# UNITED STATES PATENT AND TRADEMARK OFFICE

10/529,857

<b>Office Action Summary</b>	<b>Application No.</b> 10/529,857	<b>Applicant(s)</b> GJERTSEN ET AL.	
	<b>Examiner</b> IVES WU	<b>Art Unit</b> 1797

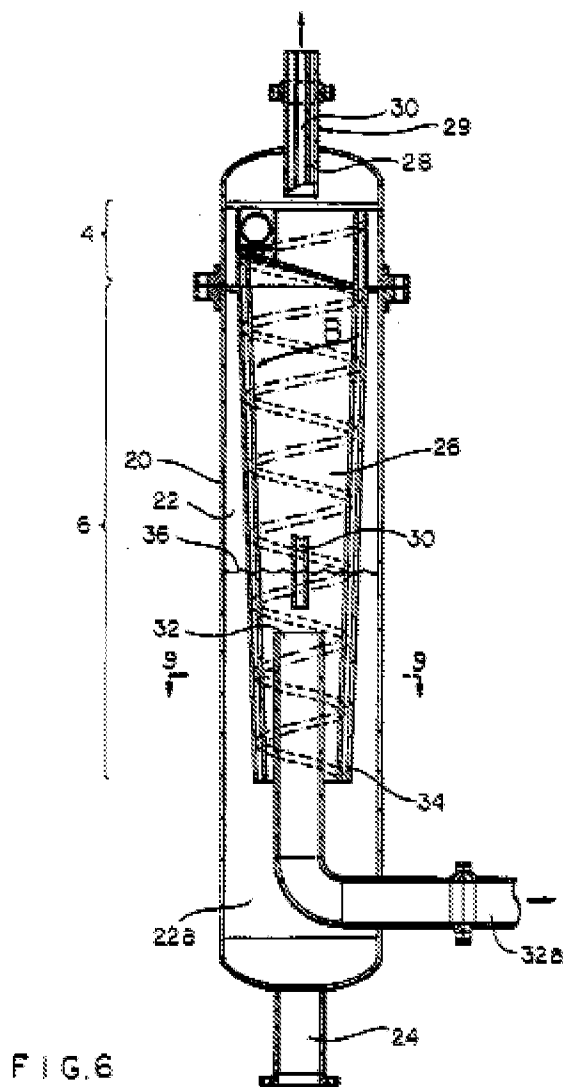
As to a fluid way to be arranged as a downward directed spiral along the innermost wall of the standing vessel, that extends from the vicinity of the fluid inlet to the vicinity of the liquid outlet, that has an opening allowing gas to escape inward to a central region of the standing vessel, such that all fluid introduced into the fluid way is passed down the full length of the fluid way, except the escaped gas in a scrubber in **independent claim 11**, Greene et al (US 6019825A) disclose Figure 6, the helical path B reads the features as claimed.

With reference to Figure 6-9, a further embodiment of the apparatus comprises a structural helical path defining means consisting of a helical dividing means situated within the annular space, bridging the width between the inner shell and the outer shell, and defining the helical path between successive turns of the helical dividing means 16 (Col. 5, line 47-52). Thus, a series of perforations 50 through the tube 16, along the length thereof, which perforations communicate the inside of the helical path 14 with the inside of the hollow tube 52, can be provided to allow for withdrawal of gases from the cycloning, mixed input stream (Col. 6, line 10-14), which reads on the limitations of instant claim.

Applicants argue that, in contrast, claim 11 of the present application, it defines a scrubber having a standing vessel arranged so that the fluid inlet directs the fluid flow tangentially along the innermost wall of the standing vessel. The fluid inlet in Greene, however, directs the fluid flow into the annular space of Greene separator, i.e., not along the innermost wall of the outer vessel 20 or the innermost wall of the inner shell or cone 10 (¶4, page 11, current Remarks). However, the helical path B in Figure 6 of Greene et al (US 6019825) still reads on the features as claimed.
